Proposal #017: 1020-06-75, WISC 2017 186
Hudson - Baldwin
STH 35 North to USH 12
IH 94
St. Croix County

This is Addendum No. 02, which provides for the following:

ADDENDUM NO. 02

1020-06-75

NOISE WALL AESTHETIC DETAILS

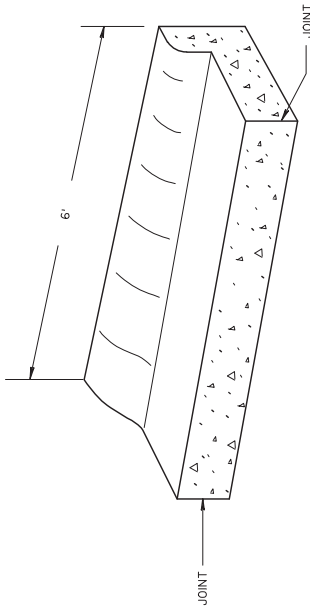
Revised Plan Sheets	
Plan Sheet	Plan Sheet Title (brief description of changes to sheet)
40	Construction Detail (added noise wall surface texture detail)
320-321	Miscellaneous Quantities (revised concrete pavements schedule)
333	Miscellaneous Quantities (revised fencing schedule)

Replace paragraph four under section titled B.3.3.1 Color and Surface Texture with the following:

The final color of the posts shall match the non-colored panels. Coating and coloring of the posts shall be shop applied.

Color – No Color
Surface Texture – Natural Stone

NATURAL STONE

MAXIMUM RELIEF: 1 1/2"
AVERAGE RELIEF: 1 1/4"
STONE SIZE: HEIGHT: 3/4" - 1 1/2"
WIDTH: 5" - 29"

Addendum No. 02
 ID 1020-06-75
 Added Sheet 466A
 June 5, 2017

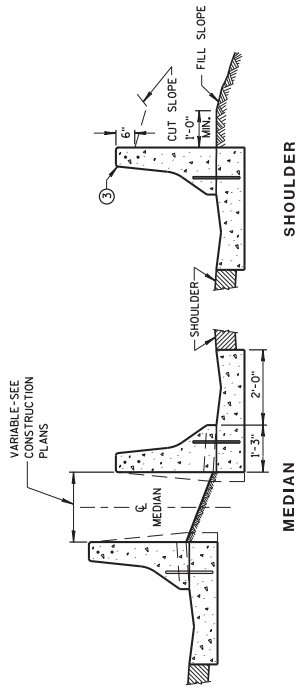
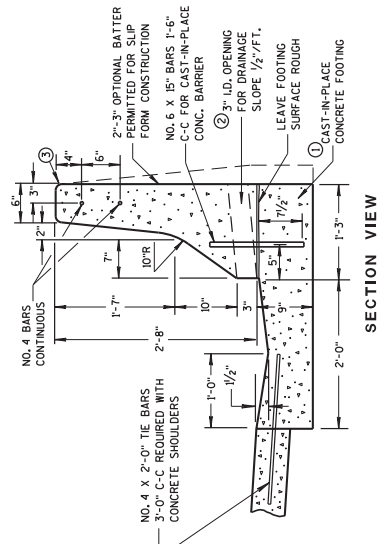
Added Plan Sheets	
Plan Sheet	Plan Sheet Title (brief description of changes to sheet)
466A	SDD – Concrete Barrier, Single-Faced (With Anchorage)
